ControlLogix™ Redundancy System

Cat. No. 1756-CNB/D, -CNBR/D, -L55, -L55M13, -L55M14, -L55M16, -L55M23, -L55M24, 1757-SRM

Publication 1756-RN582D-EN-E - November 2001

Nonvolatile Memory

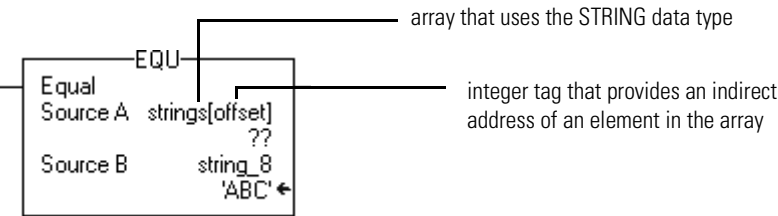
You *cannot* store or load a project to the nonvolatile memory of a 1756-L55M23 or -L55M24 controller.
